# UNITED STATES PATENT AND TRADEMARK OFFICE

APPLICATION NO.	FILING DATE	FIRST NAMED INVENTOR	ATTORNEY DOCKET NO.	CONFIRMATION NO.
10/806,593	03/23/2004	Gernot Brasen	DE920030002US1	2463

<b>Office Action Summary</b>	<b>Application No.</b>		<b>Applicant(s)</b>	
	10/806,593		BRASEN ET AL.	
	<b>Examiner</b>		<b>Art Unit</b>	
	Denise B. Anderson		2877

## **DETAILED ACTION**

FIG. 3

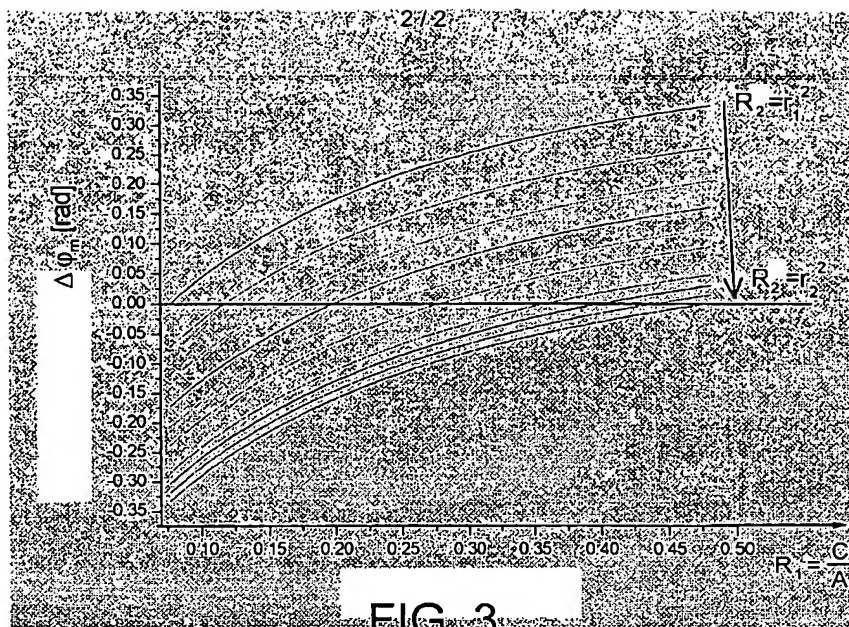
The drawings are objected to because figures 3 and 4 appear to have shading that has prohibited them from being reproduced clearly. Copies of the drawings (figures 3 and 4) are included in this Office Action. Corrected drawing sheets in compliance with 37 CFR 1.121(d) are required in reply to the Office action to avoid abandonment of the application. Any amended replacement drawing sheet should include all of the figures appearing on the immediate prior version of the sheet, even if only one figure is being amended. The figure or figure number of an amended drawing should not be labeled as "amended." If a drawing figure is to be canceled, the appropriate figure must be removed from the replacement sheet, and where necessary, the remaining figures must be renumbered and appropriate changes made to the brief description of the several views of the drawings for consistency. Additional replacement sheets may be necessary

to show the renumbering of the remaining figures. Each drawing sheet submitted after the filing date of an application must be labeled in the top margin as either "Replacement Sheet" or "New Sheet" pursuant to 37 CFR 1.121(d). If the changes are not accepted by the examiner, the applicant will be notified and informed of any required corrective action in the next Office action. The objection to the drawings will not be held in abeyance.
